Subject: Limerick Generating Station, Units 1 & 2
Information for Containment Systems Branch Regarding
Primary Containment Isolation Valves,
FSAR Table 6.2-17

Attached are draft changes to FSAR Table 6.2-17 regarding primary
containment isolation provisions to ensure that valve isolation signal
nomenclature is in agreement with the proposed Limerick Technical
Specifications. This change was discussed in the referenced telecon.

TABLE 6.2-17

CONTAINMENT PENETRATION

Insert at bottom of Pg 11 of 20

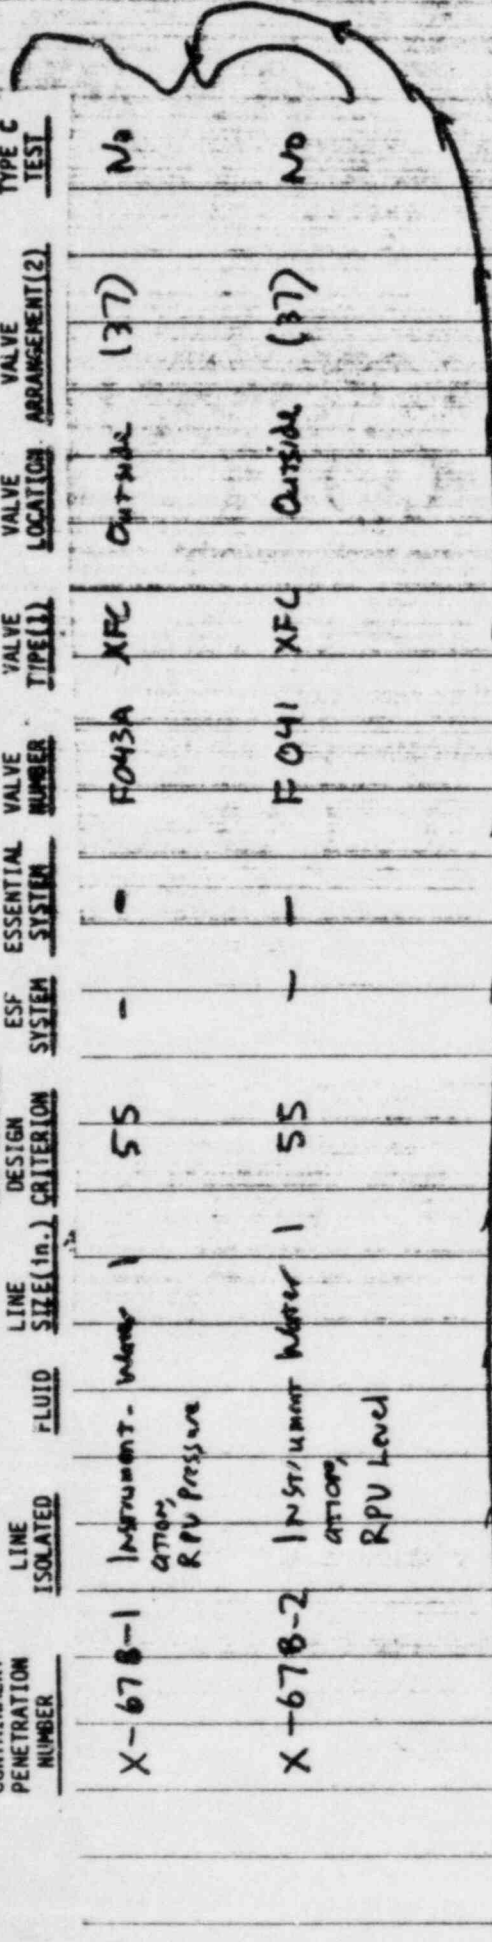
INSERT new pens X-67-B-1 & X-67-B-2 from attached sheet.
